SERVICE BULLETIN

APPLICABILITY: 2013-2014MY WRX and STI Models

NUMBER: 02-148-13R

SUBJECT: Repair Procedure for Abnormal Sound from
 Engine Mounts

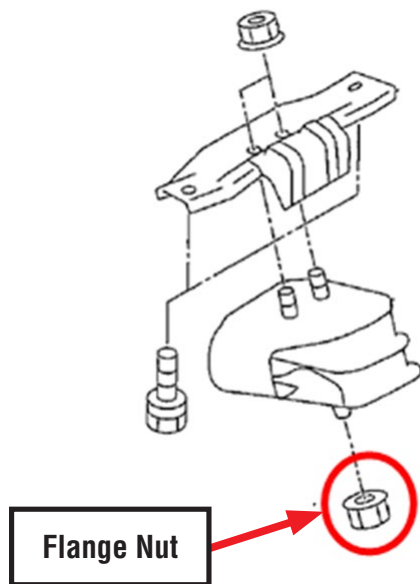
This bulletin provides a repair procedure to address customer concerns of abnormal sounds which after diagnosis, have been determined to be coming from the engine mounts. In some cases, the vehicle's usage patterns may put excessive force on the lower engine mount retaining nuts. The torque specification for these nuts has been revised accordingly.

The torque specification for the lower engine mount nut has been increased from 45Nm (33 Ft. Lbs.) to 60Nm (44 Ft. Lbs.) This new specification is a running change incorporated into production starting with the following VINS:

One-Time Use Item
Torque to 60Nm (44 Ft. Lbs.)

Confirm the customer concern is being caused by the engine mount condition as described in this bulletin. Always replace **BOTH** the left and right side flange nuts if either is found to be loose or missing. Whenever removing a flange nut, inspect the threads of the engine mount stud closely and replace the mount if any damage is found. When installing the new flange nuts, torque to 60Nm (44 Ft. Lbs).
